Author response to reviewer comments

Anonymous Referee # 1

Omara et al compiled previously reported methane measurement data to study methane emissions from major US oil and gas producing basins, and developed a high spatial resolution emission inventory for 2021. I find the methods solid and the manuscript well-written. I only have some minor comments.

Supplementary Fig. 8. Assessment of mean total methane emissions within each 0.1° × 0.1° grid (~10 km × 10 km) grid cell and correlation with mean well site age.

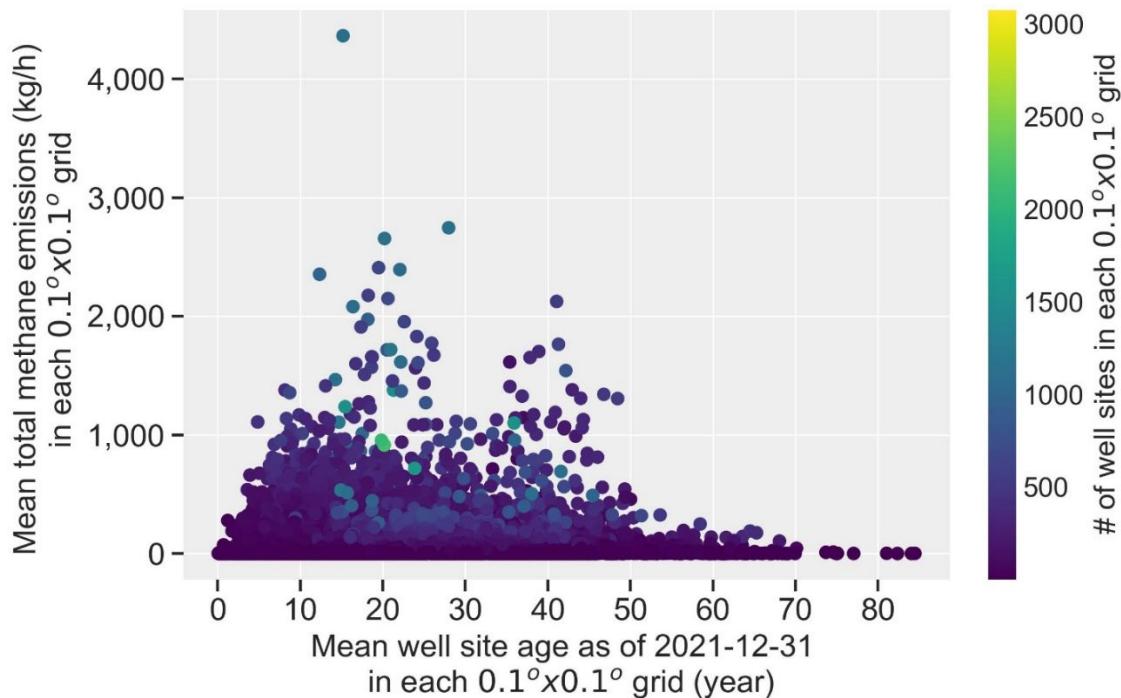
(1) As age of wells is important to methane emissions, would the authors add a plot to show the correlations between age of wells and methane emissions?

- The available measurement data on facility-level well site methane emissions do not generally include information on age of well sites at the time of measurement, and our model does not directly assess the influence of well site age on methane emissions. In general, the potential for fugitive methane emissions to occur at actively producing well site infrastructure is expected across well sites of varying age, a factor which contributes to a general lack of correlation of well site emissions with age (see, for example, Brantley et al., 2014).

- Using proprietary data from Enverus Prism (www.enverus.com), we computed the mean age of well sites within each 0.1° × 0.1° grid (~10 km × 10 km) on which we aggregated mean total methane emissions. We compute the mean age as the average of the age of all actively producing well sites as of 2021-12-31. Figure AR1 below shows that there is essentially no correlation between the mean age and the mean total methane emissions within each grid cell, consistent with the findings from Brantley et al. (20214). Note, however, that we are not directly assessing correlations here because of limited information which precludes explicit treatment of well site age as a variable in our models (i.e., well site age is generally not reported in the measurement-based data).

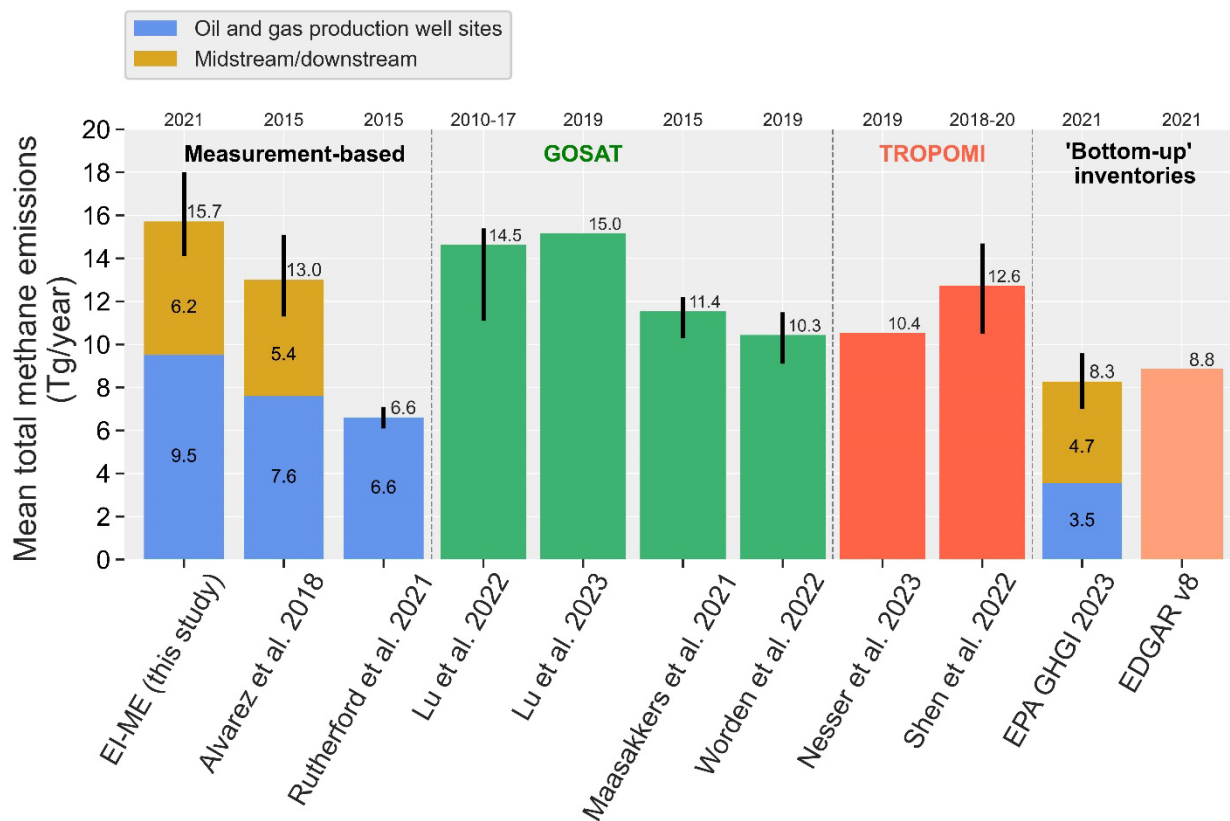
235   • We have revised the following sentence as follows:
         "Given the scarcity of facility-level measurements for gathering and transmission
         pipelines, we use the emission factors estimated by the US EPA Greenhouse Gas Emission
         Inventory (EPA, 2022; 285 kg methane/mile/year and 582 kg methane/mile/year,
         respectively) and assume normal distributions of emission factors with 50% uncertainty.
240   *Our use of EPA's GHGI emission factors for oil and gas pipelines makes it possible to*
         provide a more complete spatially explicit inventory of oil and gas methane emissions
         (inclusive of gathering and transmission pipelines for which we have geospatial activity
         data), but likely increases uncertainties in our total methane estimates given potential
         underestimation in the GHGI emission factors."
245
       Figure 4: (1) why is the yellow bar for EDGAR hatched? (2) I suggest moving the year for each study from

the bottom of the figure to the top.

We have revised Figure 4 as follows:

Figure 5. Basin-level differences in modeled mean total methane emissions and comparison with the EPA GHGI (Maasakkers et al., 2023), TROPOMI-derived estimates (Shen et al., 2022) and GOSAT-derived estimates (Lu et al., 2023).

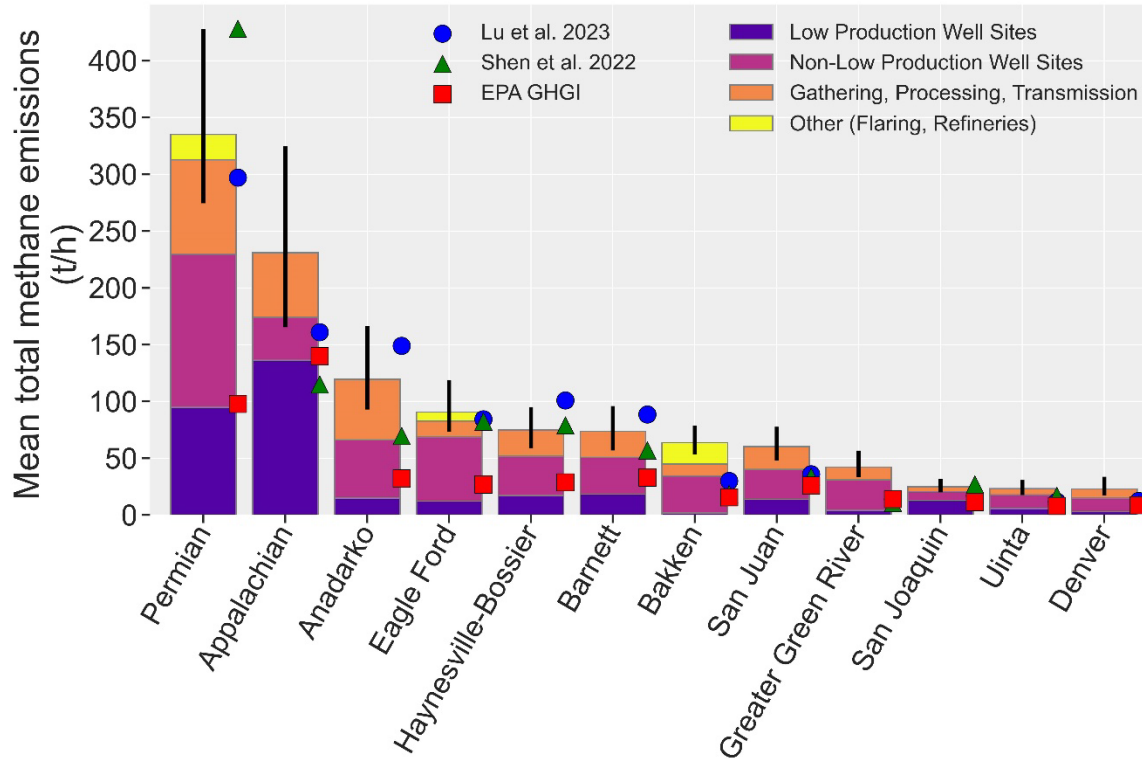
Figure 5. The colors are similar and difficult to distinguish.

We have revised Figure 5, reducing the number of classes, for ease of readability.
